THIS AUTOCAD DRAWING HAS BEEN REVISED AND REPLOTTED SUBSEQUENT TO INTERNAL ENGINEERING APPROVAL AND SIGN-OFF. FOR THOSE SIGNATURES, SEE THE DRAWING PLOTTED AND ISSUED PREVIOUSLY DURING BIDDING. THE SIGNED DRAWING REMAINS VALID EXCEPT FOR THE CHANGES ONLY AS CLEARLY MARKED ON THIS DRAWING AND ISSUED UNDER THIS LATEST REVISION NUMBER AS SHOWN IN THE TABLE OF REVISIONS LOCATED AT THE LOWER LEFT CORNER OF THE DRAWING. ALL ISSUED REVISIONS SUBSEQUENT TO PREVIOUSLY PLOTTED DRAWING DURING BIDDING REMAIN VALID UNLESS SUPERSEDED BY LATER ISSUED REVISIONS. CHECK ALL ISSUED REVISIONS OF THIS DRAWING.

REFERENCE INFORM & FILE NO. OF SUF
1	10/28/20	PCO#2 POLE RELOCATION	KS/MA	MV	
NO.	DATE	DESCRIPTION	BY	APP.	
THIS	DRAWING V	TABLE OF REVISIONS WAS LAST MODIFIED: 02/23/21 15:4:	5, BY: MAung

19TH AVENUE (STATE ROUTE 1)	CONTRACT NO. 1000005832
COMBINED CITY PROJECT	DRAWING NO. E-19.0
19TH AVENUE AND JUDAH STREET	FILE NO. 111,416
ISIN AVENUE AND JUDAN SIKEEI	REV. NO.

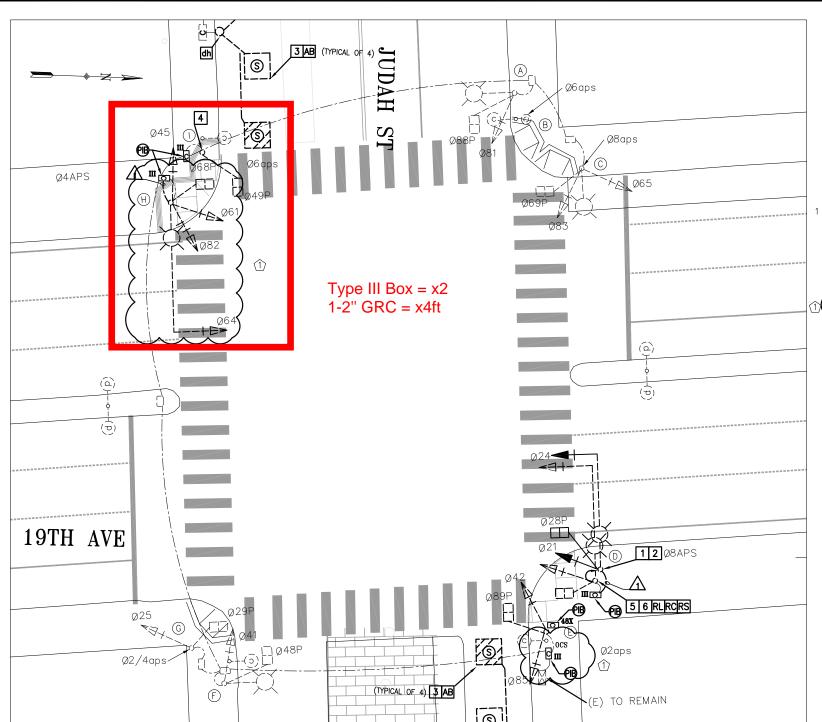
- 5 CONTACT SFMTA SIGNAL SHOP 5 DAYS PRIOR TO CONSTRUCTION TO RS GTT TRANSIT SIGNAL PRIORITY RADIO EQUIPMENT.
- 6 REUSE AND RL EXISTING MAST ARM POLE AS INDICATED BY POLE D ON NEW FOUNDATION. RL EXISTING STREET LIGHT FIXTURE. RC EXISTING TRAFFIC SIGNAL EQUIPMENT, MOUNTINGS, ASSOCIATED CONDUIT, AND FOUNDATION. PROVIDE NEW TRAFFIC SIGNALS AND MOUNTINGS PER POLE AND EQUIPMENT SCHEDULE. PROVIDE TEMPORARY SIGNAL AND LIGHTING AS REQUIRED.
